Access Compliance Report

Public Rights-of-Way

Intersection ID: 14857	Main Street: ATHERTON_ST	Cross Street: SOUTH_BV	Location: S
ADA ID: 83DA5317C2D8	Ramp Type: Perp	Initial Pass/Fail: Fail	Overall Compliance: No
Severity Score: 35			
Codes/Mitigation Info/Possible Solution		Field Measurements/Component Compliance

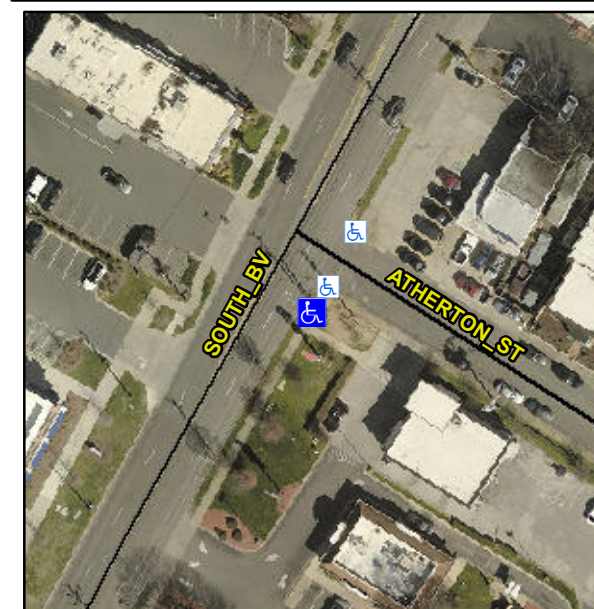
Not Found, R304.5.1, R304.2.2

Compliance	Description	Data	Compliance	Description	Data
N/A	Ramp Length (in)	51.0	No	Ramp Slope (%)	14.1
No	Ramp Width (in)	37.0	Yes	Ramp XSlope (%)	3.7
N/A	Flare Type LT	N/A	N/A	Flare Type RT	N/A
N/A	Flare Slope LT (%)	N/A	N/A	Flare Slope RT (%)	N/A
N/A	Flare Traversable LT?	N/A	N/A	Flare Traversable RT?	N/A
N/A	Landing Length (in)	N/A	N/A	DWS Provided?	N/A
N/A	Landing Width (in)	N/A	N/A	DWS Contrast?	N/A
N/A	Landing Slope (%)	N/A	N/A	DWS Length (in)	N/A
N/A	Landing X Slope (%)	N/A	N/A	DWS Full Width?	N/A
N/A	Landing Curb? (Y/N)	N/A	N/A	DWS Offset (in)	N/A
N/A	Shared Landing?	N/A			
N/A	Gutter Ponding?	N/A	N/A	Gutter Slope (%)	N/A
N/A	Gutter Lip Ht (in)	N/A	N/A	Gutter X Slope (%)	N/A
N/A	Painted X Walk1?	No	N/A	Painted X Walk2?	N/A
	X Walk 1 Direction	To NW		X Walk 2 Direction	N/A
N/A	X Walk 1 Width (in)	N/A	N/A	X Walk 2 Width (in)	N/A
	X Walk 1 Slope (%)	4.1		X Walk 2 Slope (%)	N/A
	X Walk 1 X Slope (%)	3.9		X Walk 2 X Slope (%)	N/A

Remove & Replace Entire Ramp.
